April 4, 2017

RE: 1210 BRIGHTON AVENUE

REVISIONS TO HOTEL REDEVELOPMENT

Existing 18" Culvert

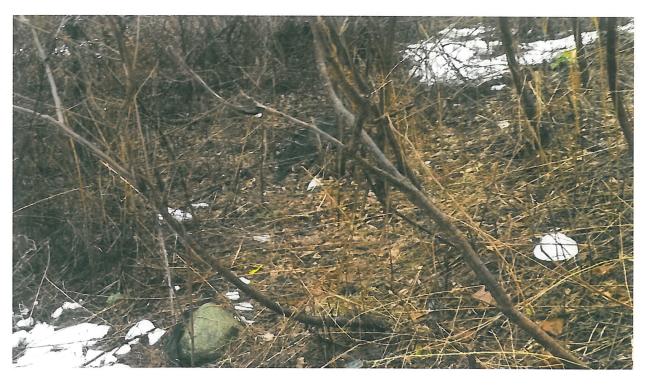
Attached are photographs of the area of AP#2 discharge. We are detailing the plunge pool on sheet C7.6 for the discharge. The water is currently going in that direction and will continue to in the developed condition. The outfall will be stable.
